Transmission Expansion Advisory Committee Supplemental Projects

PPL Transmission Zone

Scope Change

Supplemental #: S0866 (2015 TEAC)

PPL Transmission Zone: Supplemental Martins Creek, PA

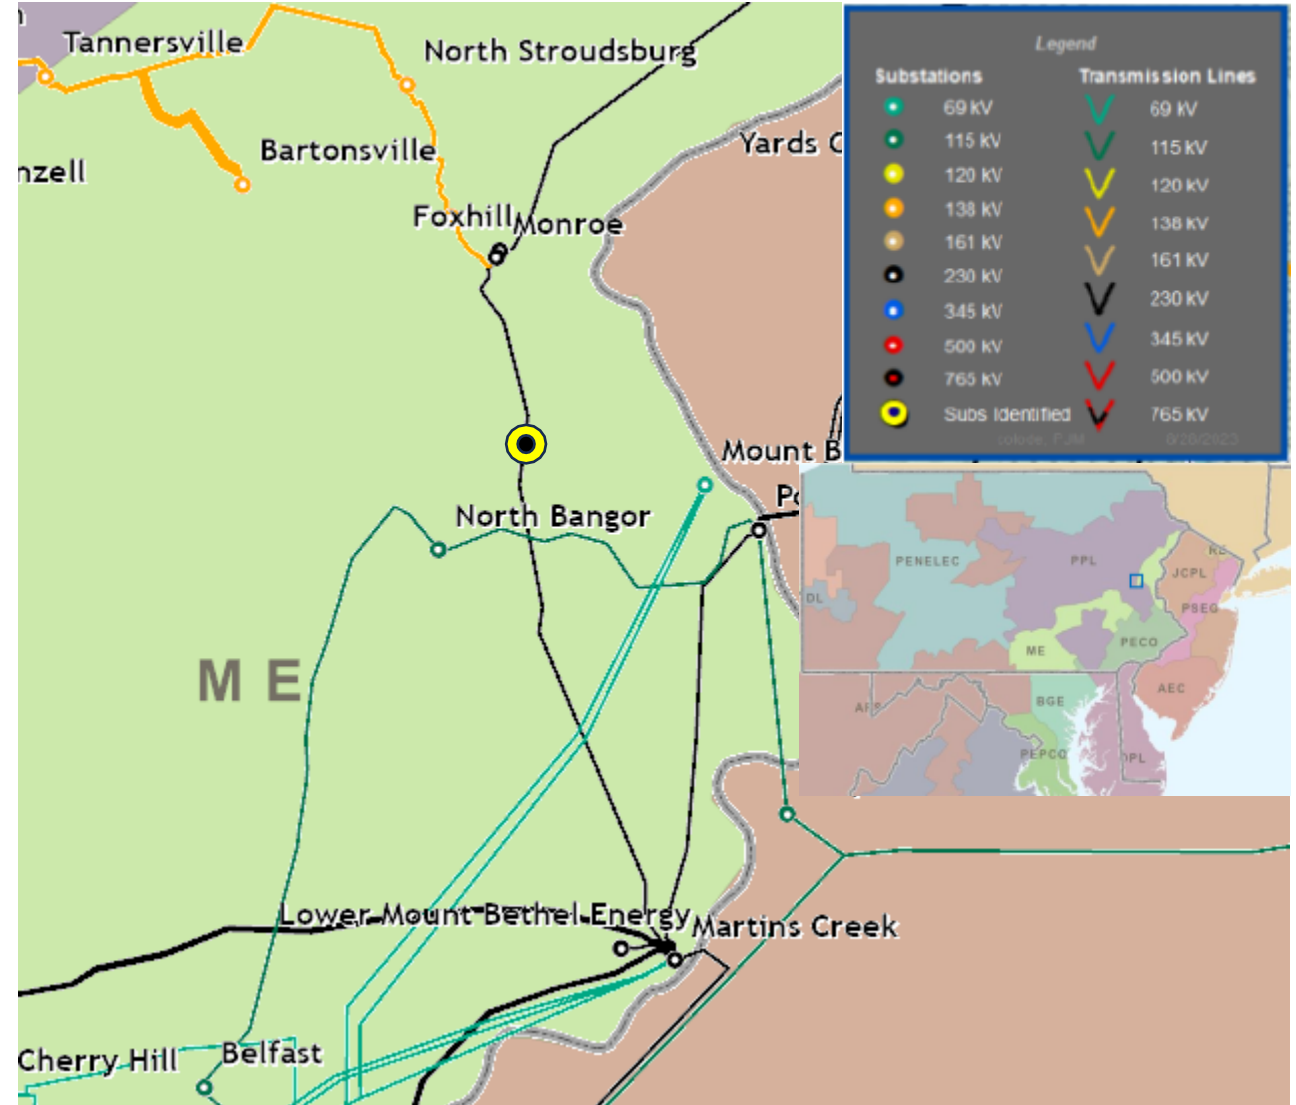
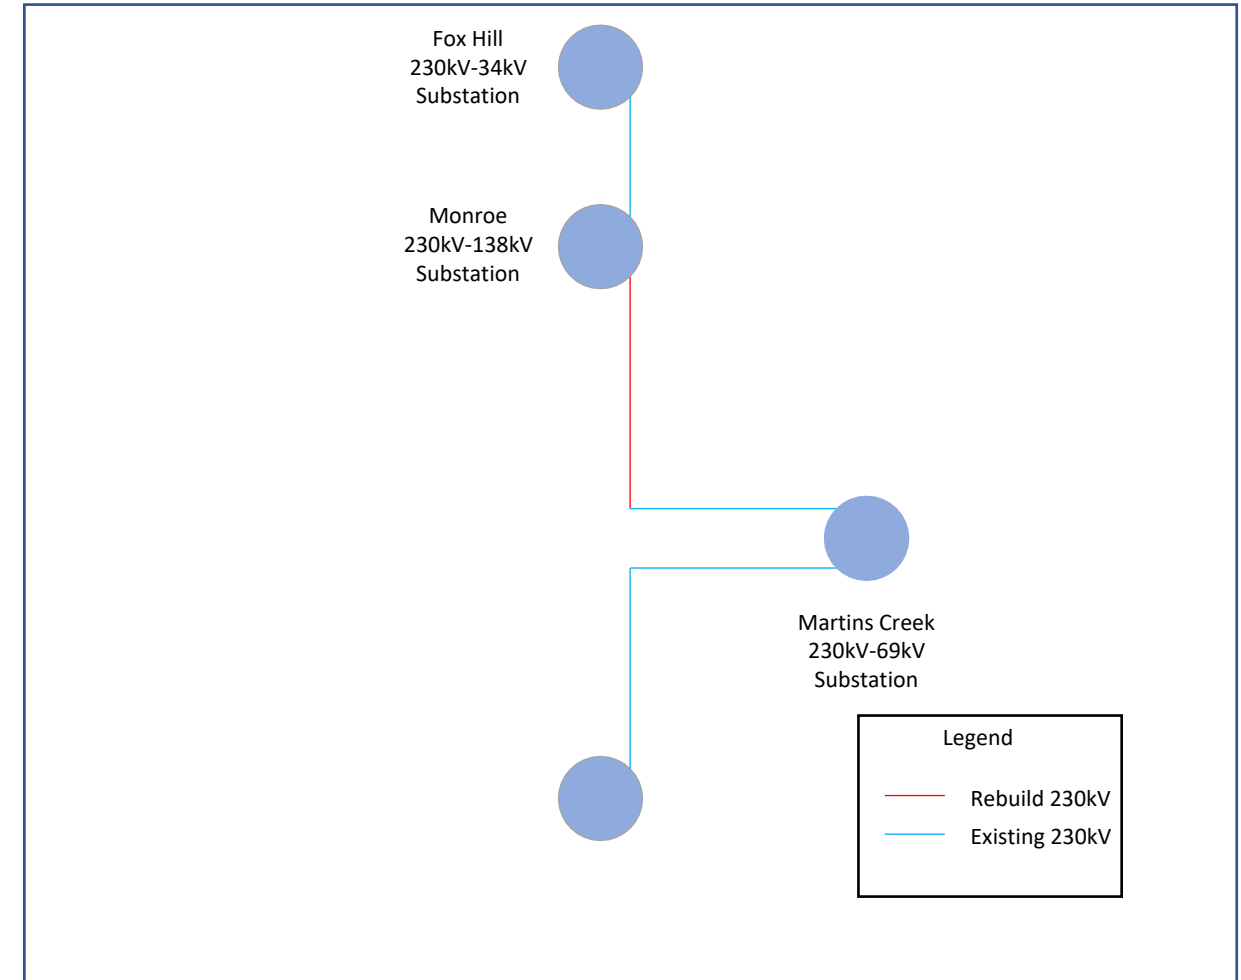
Original Scope: Build a new 230 kV circuit from Martins Creek to Monroe using existing Martins Creek-Stroudsburg 69 kV decommissioned line and reconfigure Martins Creek and Monroe substations.

Revised Scope: Rebuild the 15.75-mile-long 1926 tower section of the existing Martins Creek – Monroe 230kV line.

Estimated Project Cost: ~~\$44.86M~~ **\$66.9M**
